**ROCKFORD BOARD OF EDUCATION
INVITATION FOR BID ON SUPPLIES, MATERIALS, EQUIPMENT OR SERVICES
FOR SCHOOL DISTRICT NO. 205
ROCKFORD, ILLINOIS**

IFB No. 22-23 HVAC & Roofing Projects at Lincoln, East, Washington & Flinn Schools

RE: **ADDENDUM NO. 9**

FIRST FLOOR REFLECTED CEILING PLAN - AREA B

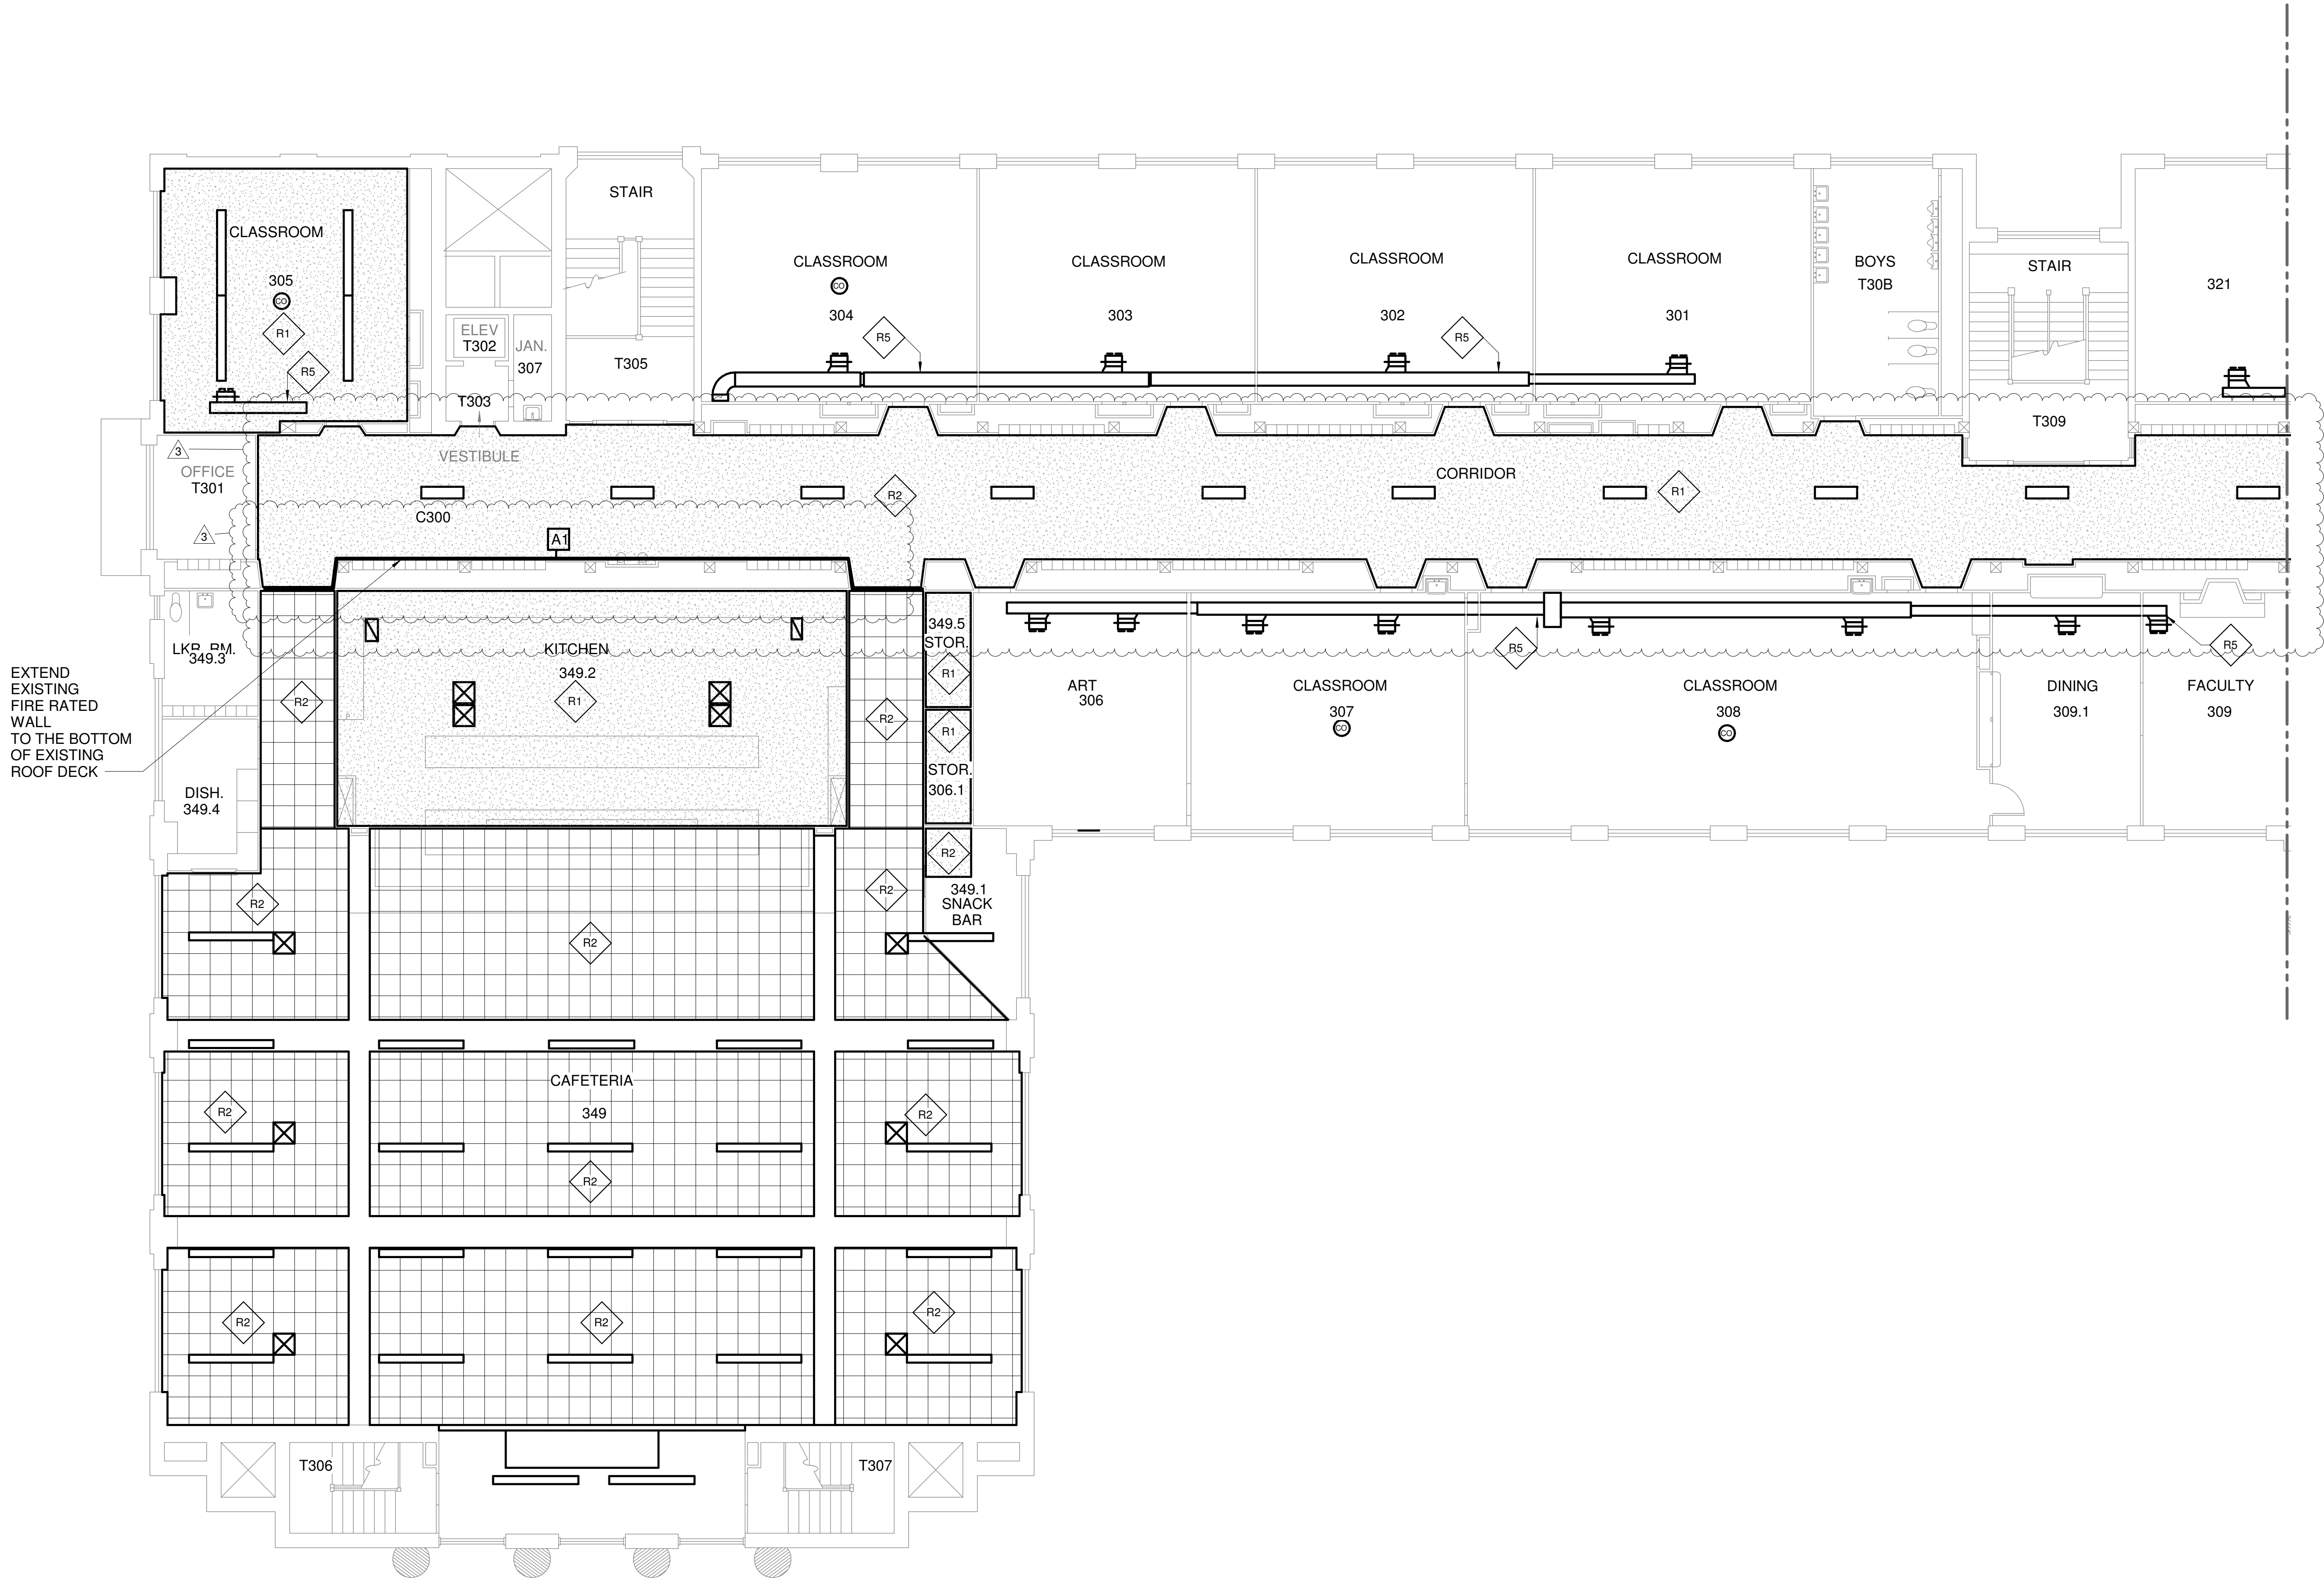
1. DRAWING A2.01B – FIRST FLOOR REFLECTED CEILING PLAN – AREA B **REPLACE** entire sheet with A2.01B – FIRST FLOOR REFLECTED CEILING PLAN – AREA B dated 03/10/2022.
 - a. **DELETE** tag RCP3 in the swimming pool.

THIRD FLOOR REFLECTED CEILING PLAN - AREA A

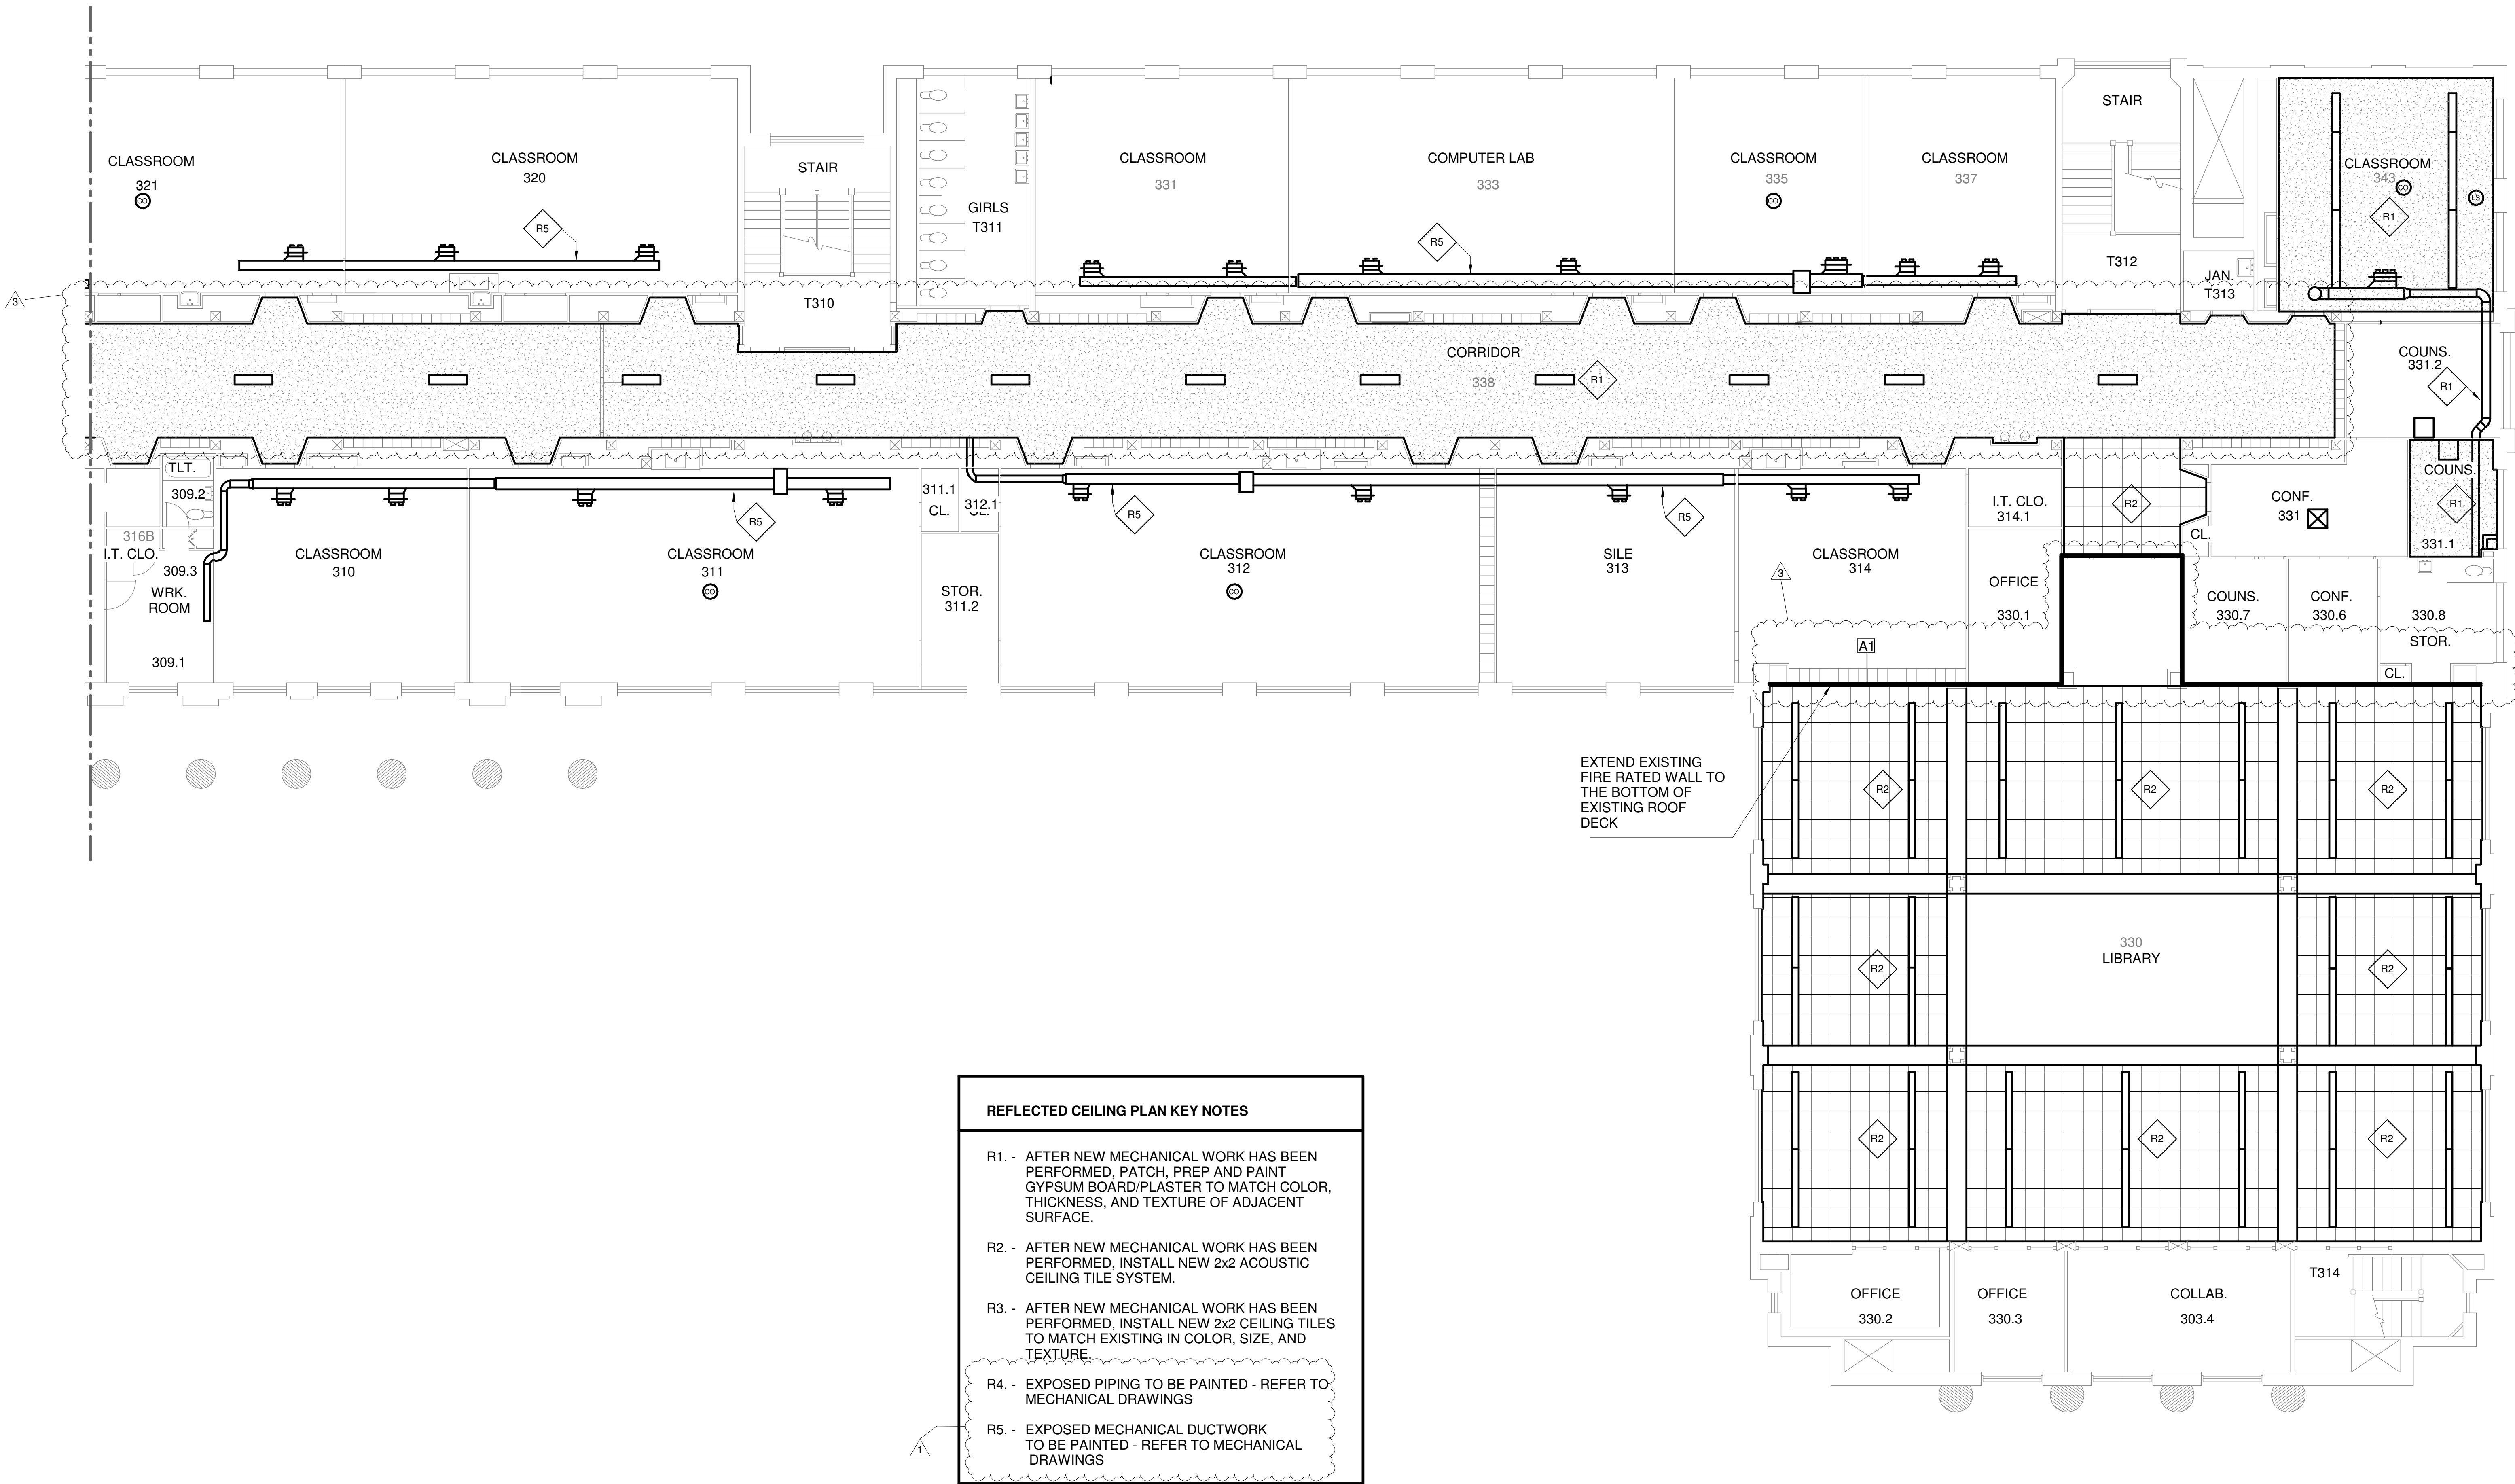
2. DRAWING A2.04A THIRD FLOOR REFLECTED CEILING PLAN – AREA A **REPLACE** entire sheet with A2.04A THIRD FLOOR REFLECTED CEILING PLAN – AREA A dated 03/10/2022.

- a. **ADD** note “Extend existing fire rated wall to the bottom of existing roof deck” between Cafeteria 349 and Corridor.
3. DRAWING A2.04C THIRD FLOOR REFLECTED CEILING PLAN – AREA A C **REPLACE** entire sheet with A2.04C THIRD FLOOR REFLECTED CEILING PLAN – AREA C dated 03/10/2022.

**THIRD FLOOR
REFLECTED
CEILING
PLAN - AREA C**

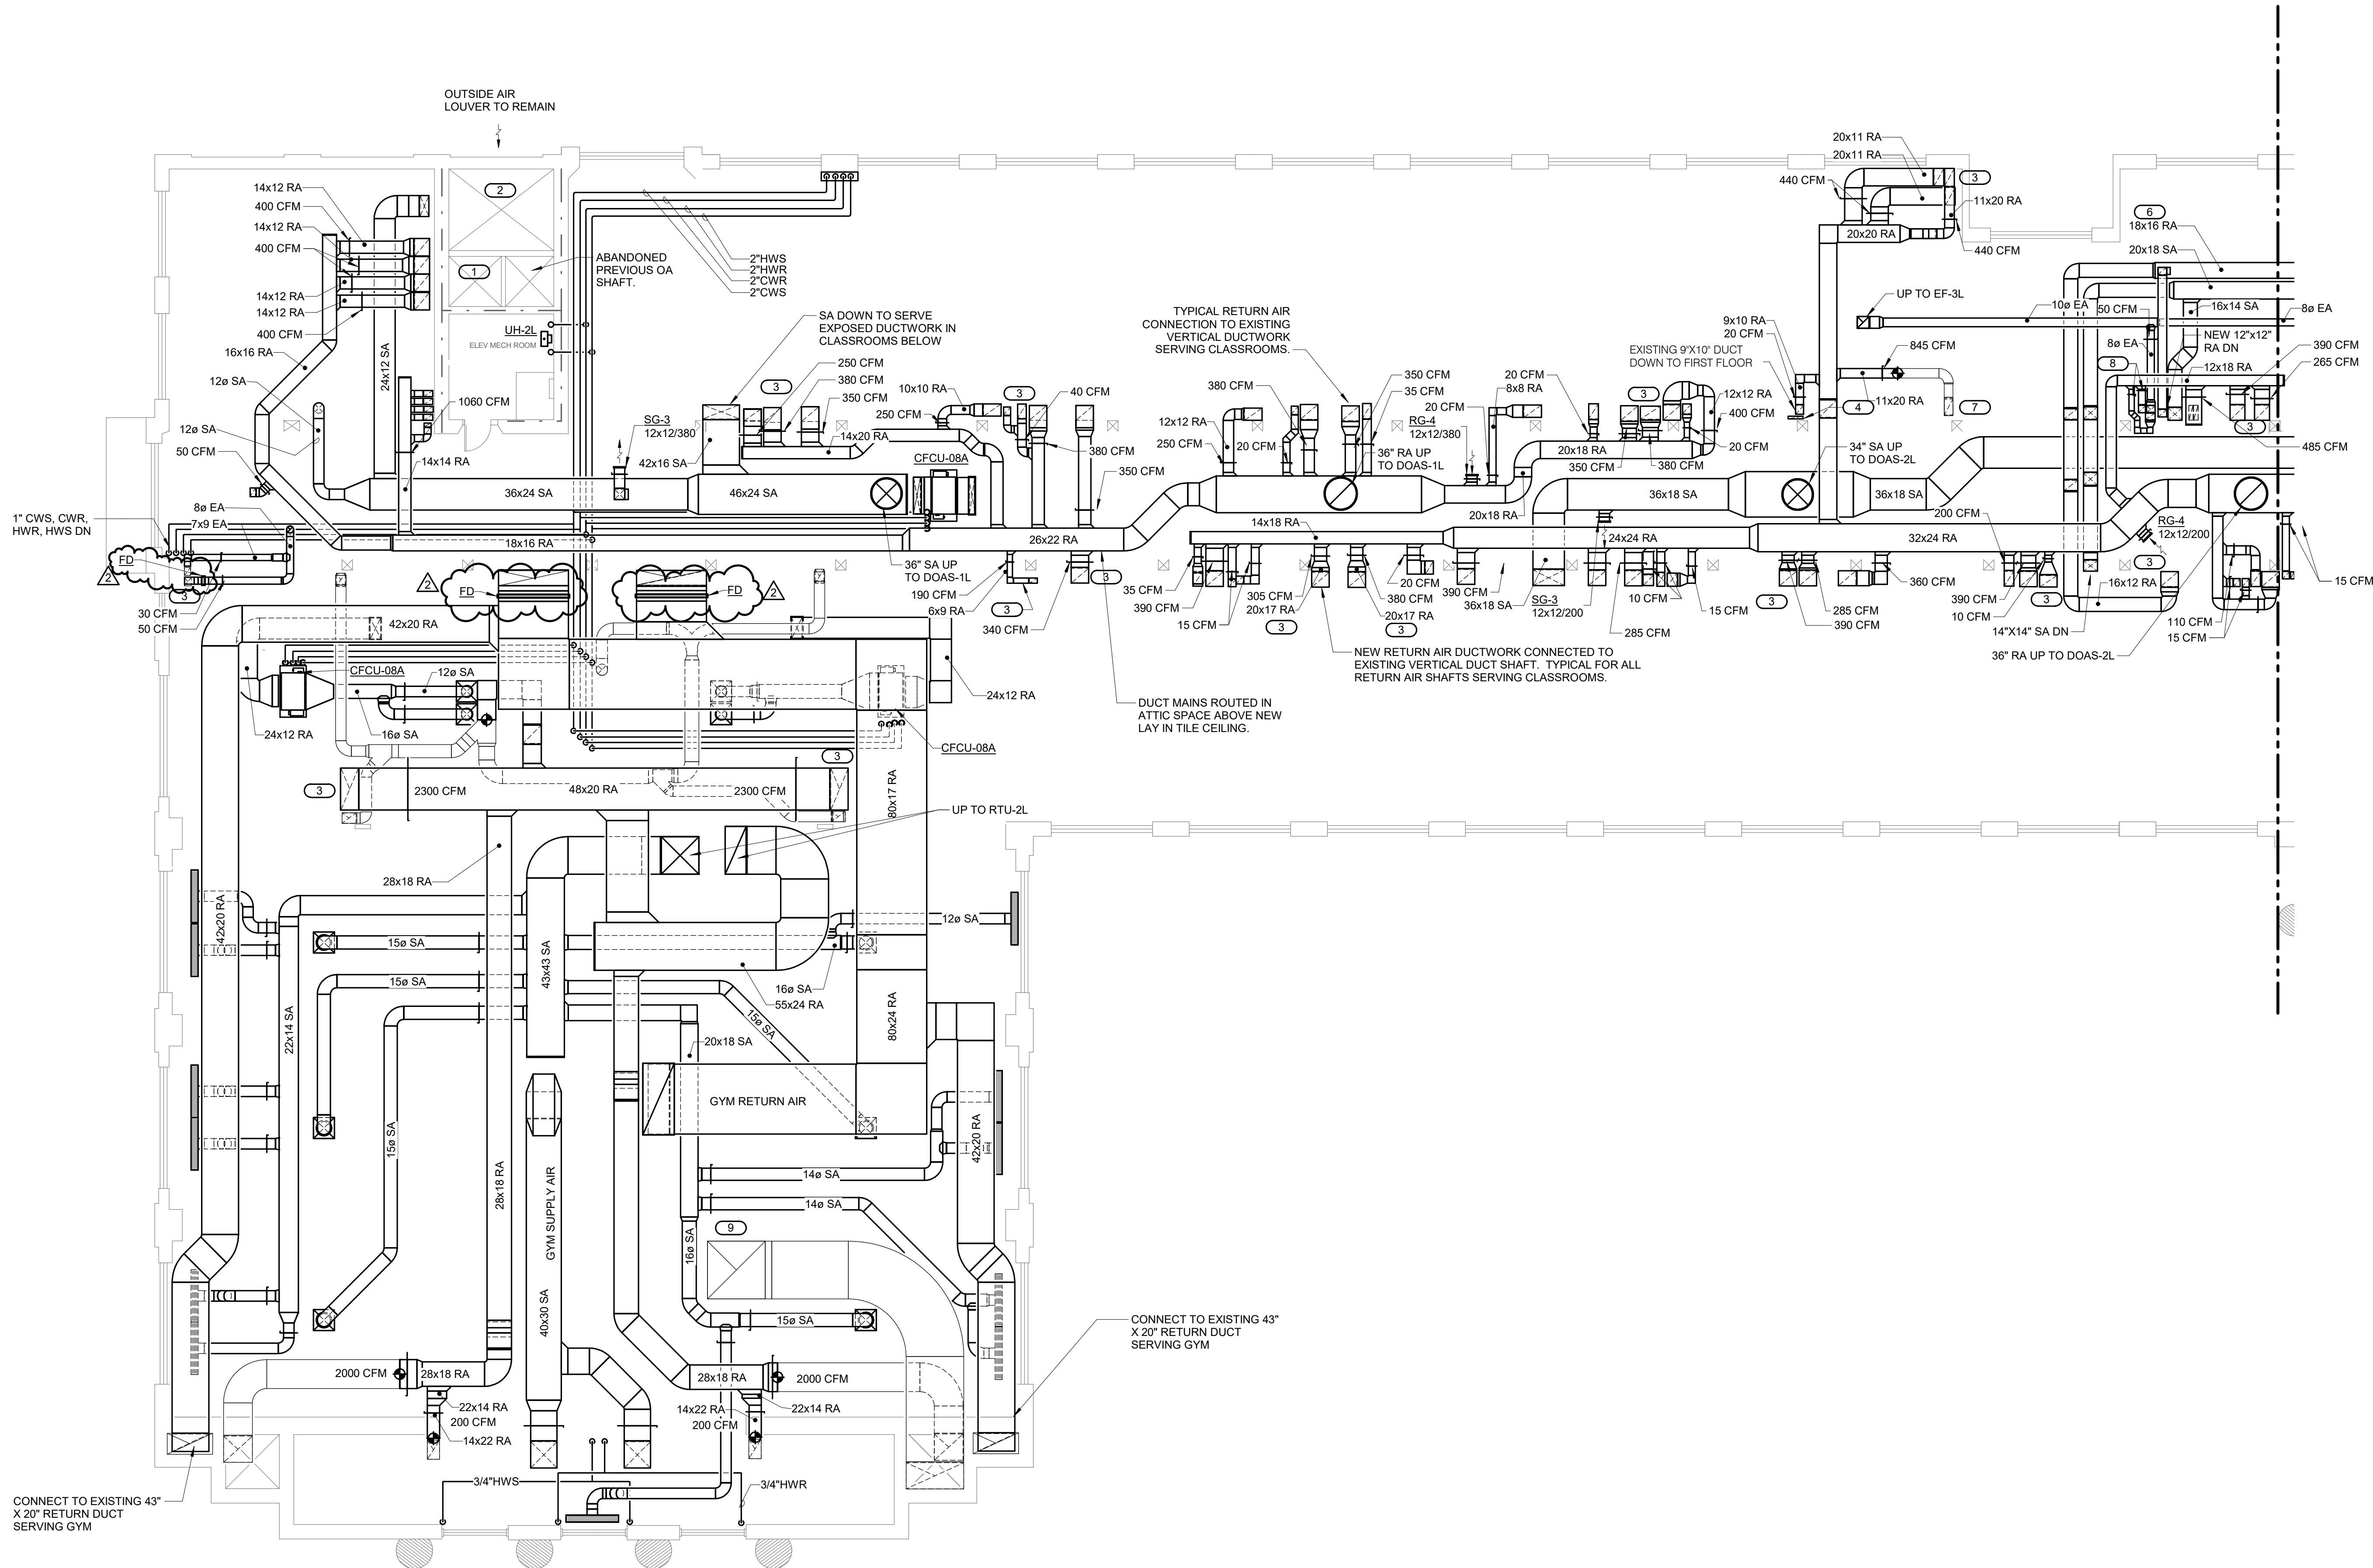
- a. **ADD** note “Extend existing fire rated wall to the bottom of existing roof deck” between Library 330 and Corridor.
4. DRAWING M206A - MECHANICAL SCHEDULES
